March 10, 2023

Project Name: PEARL JUNIOR HIGH MULTIPURPOSE
Project No: 22-056
RE: Updated Civil and Structural drawings.

ADDENDUM NO. 01

S304
DETAILS

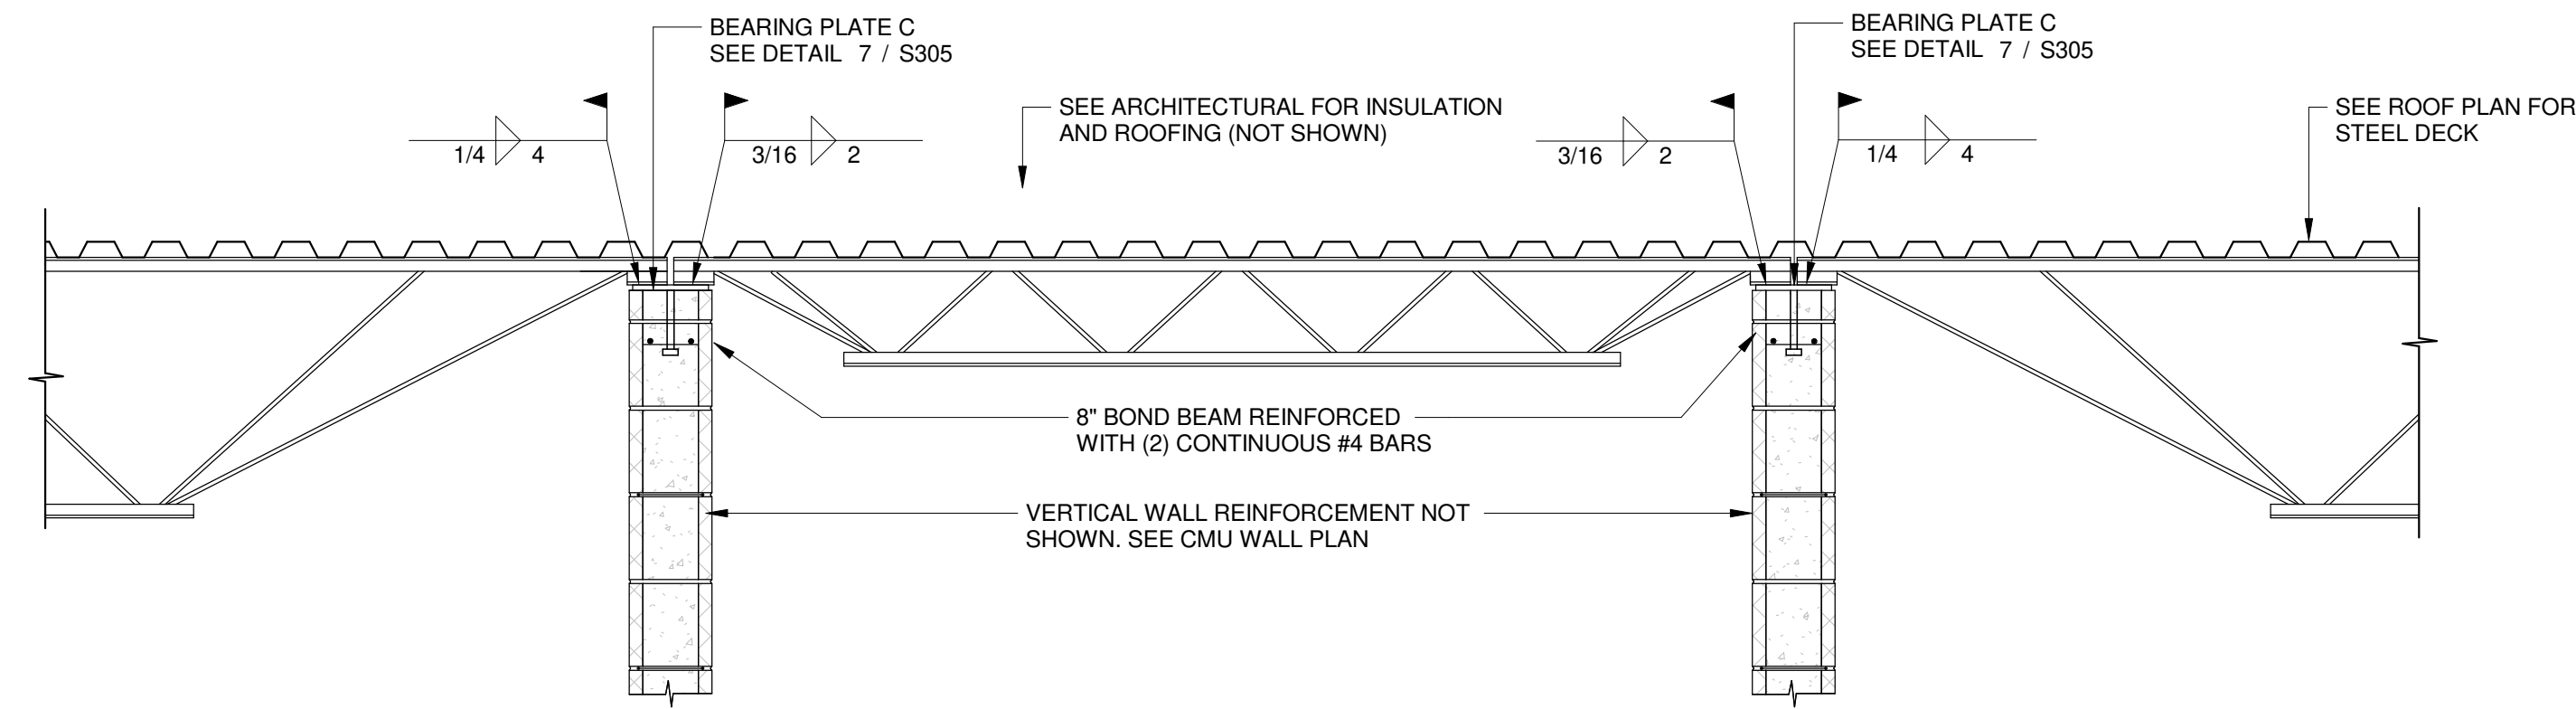
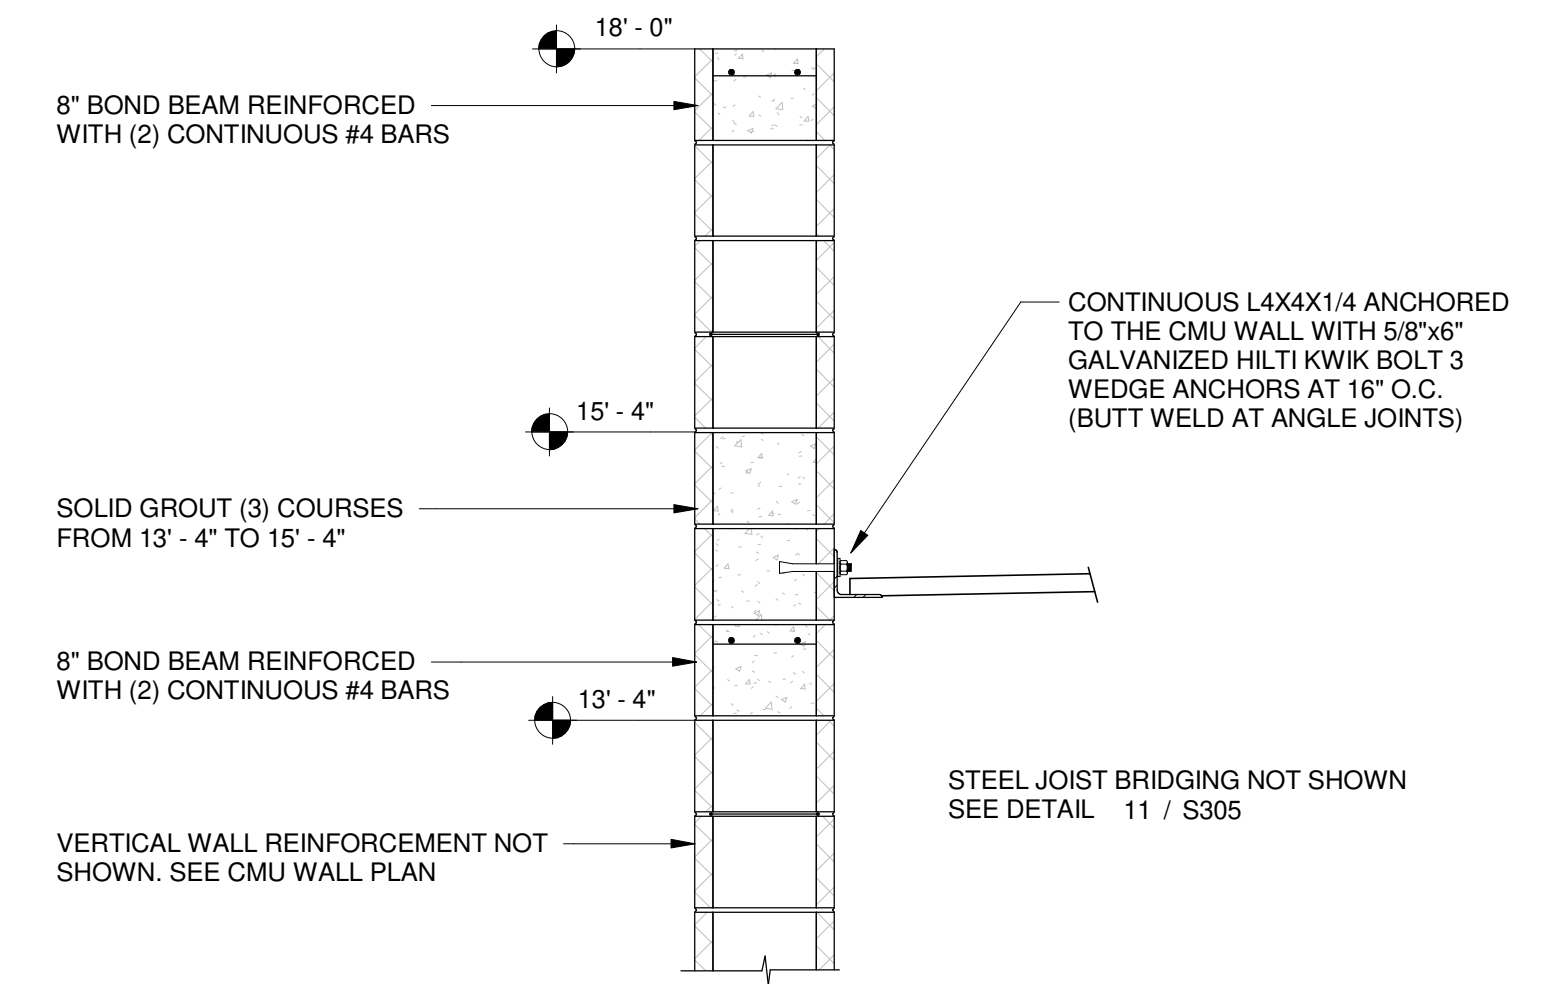
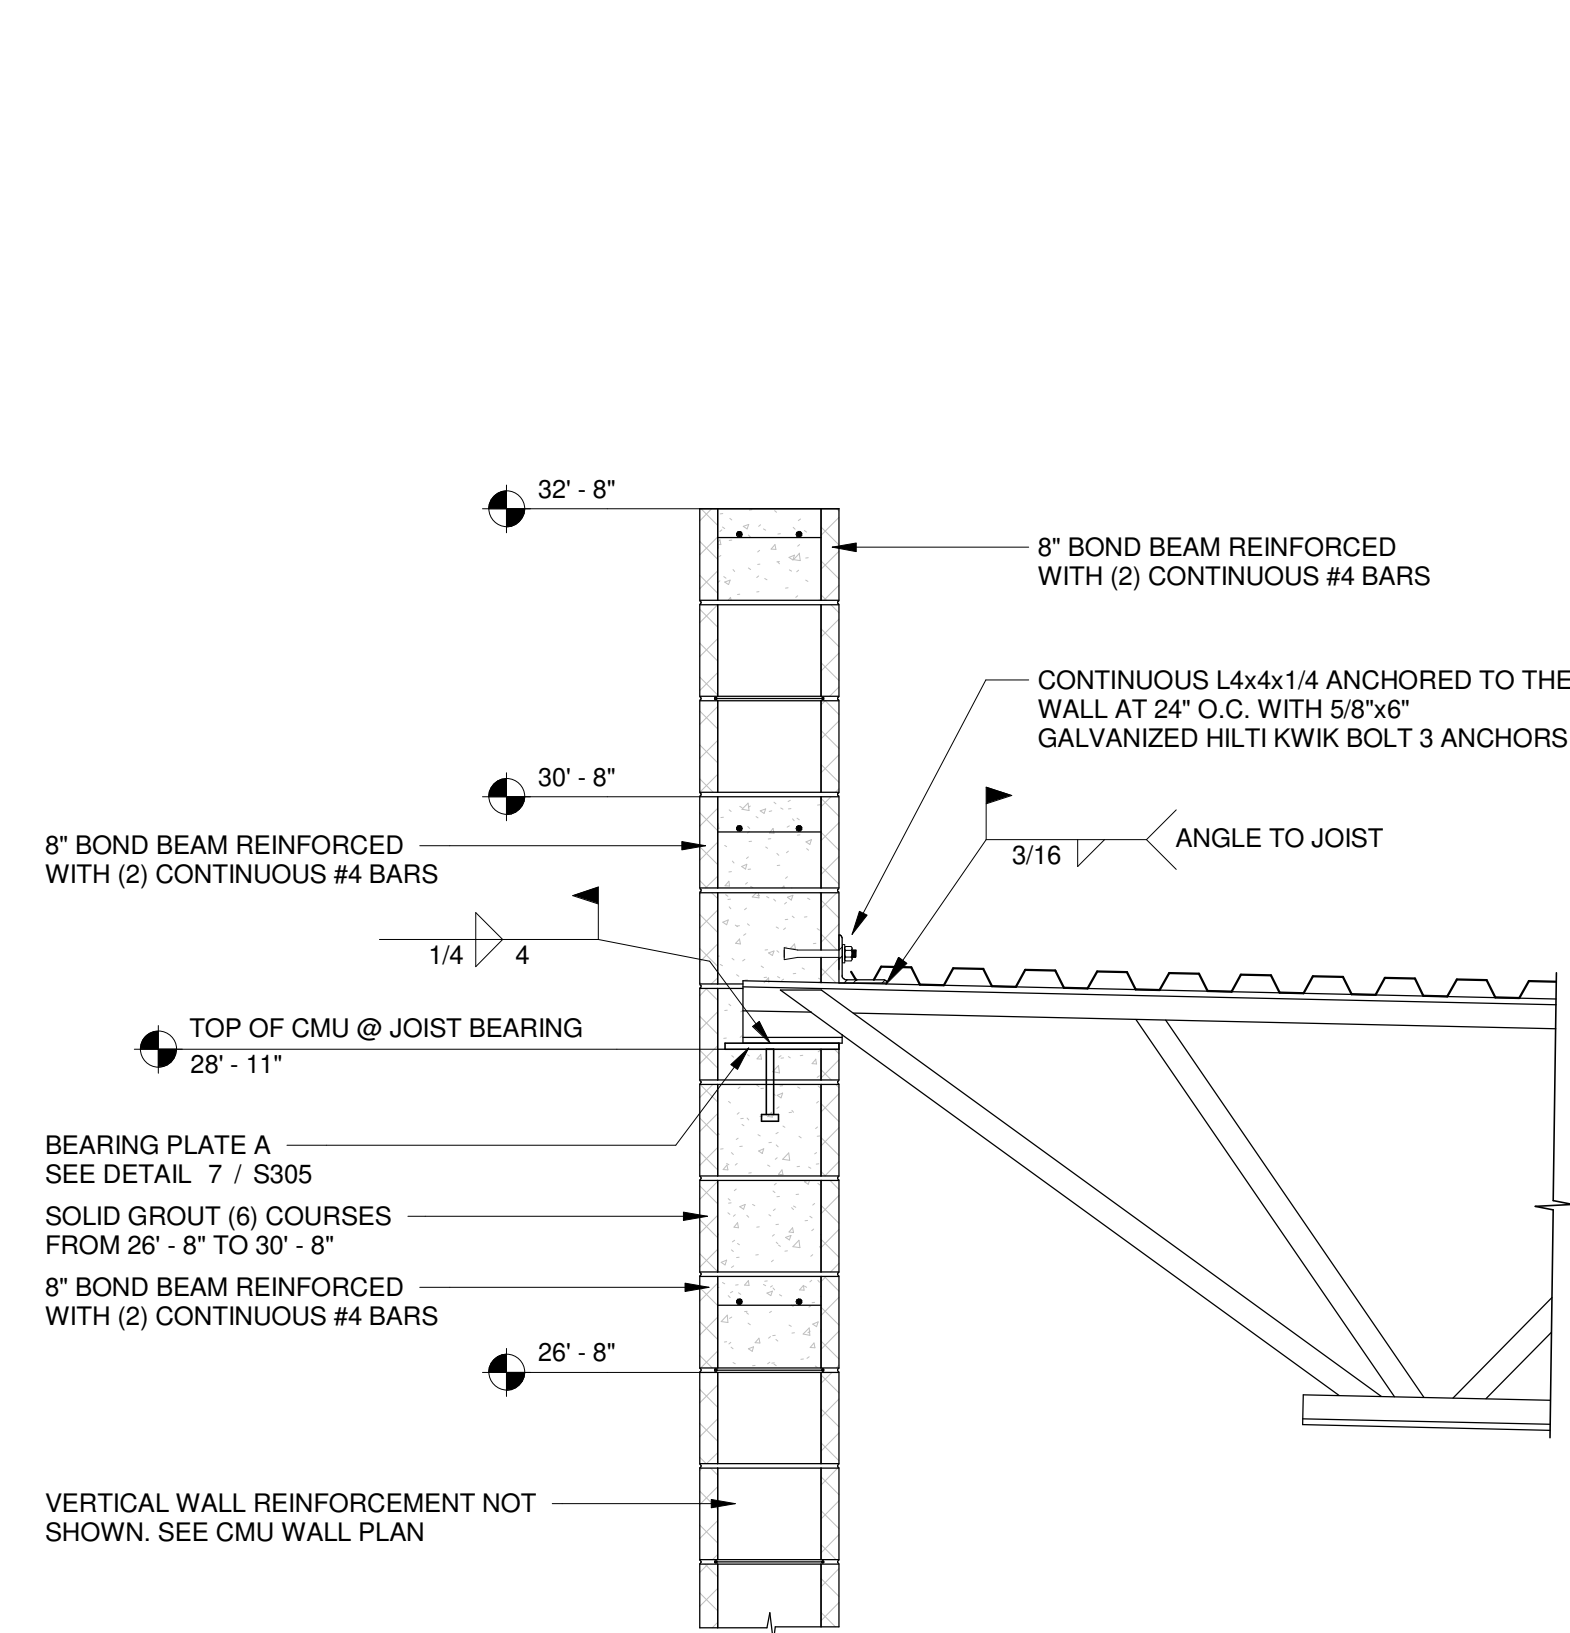
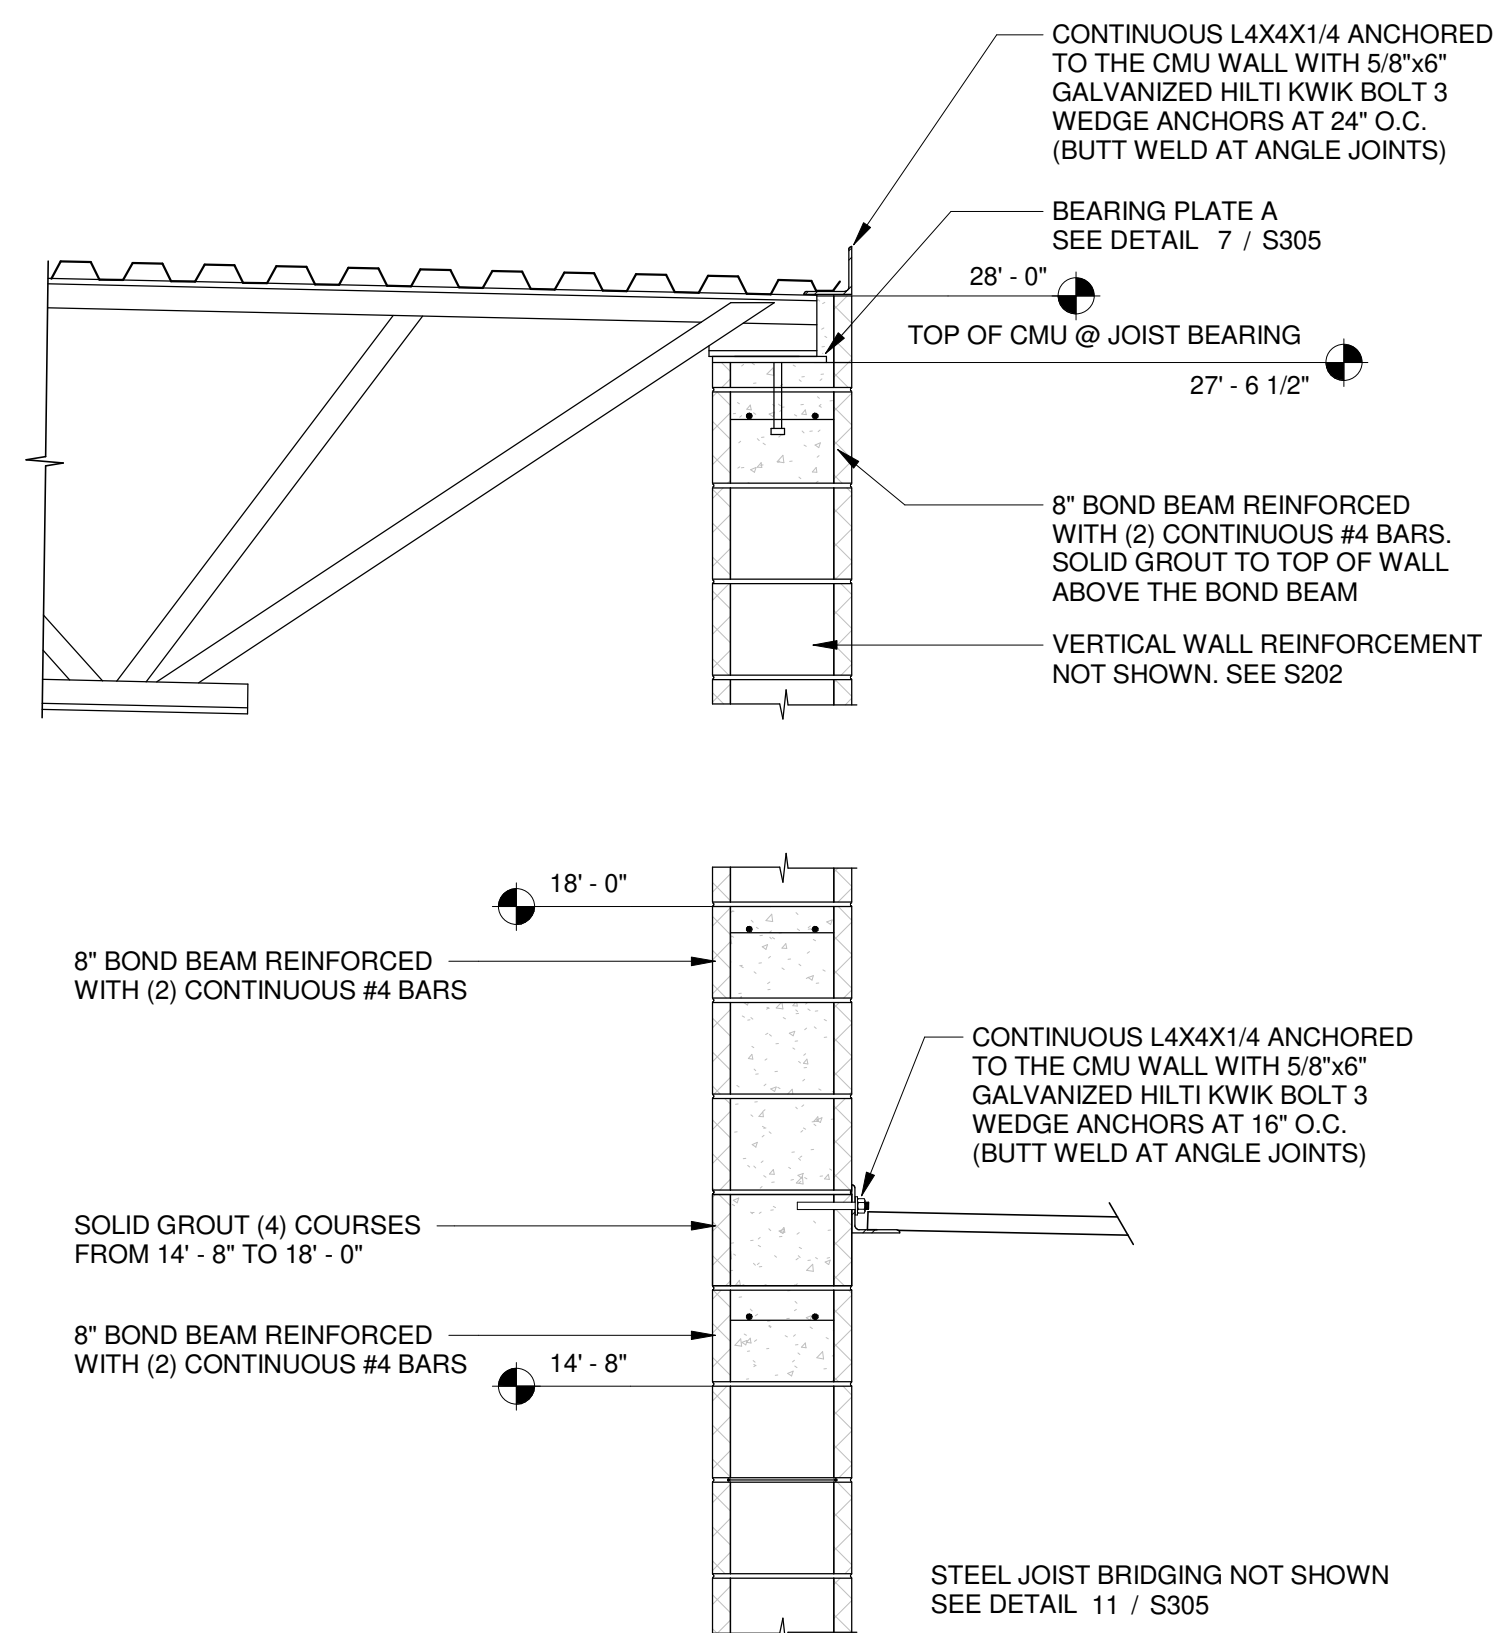
- S302 DETAILS
 - Modified top of slab level and exterior stair detail.
- S303 DETAILS
 - Added sections for mechanical screen wall.
- S304 DETAILS
 - Modified wall sections.
- S305 DETAILS
 - Modified details.
- A109 OVERALL ROOF PLAN
 - Modified the dimension of the mechanical screen.
- A402 INTERIOR DETAILS – ALTERNATE 1
 - Modified the spacing of the acoustical sealant.
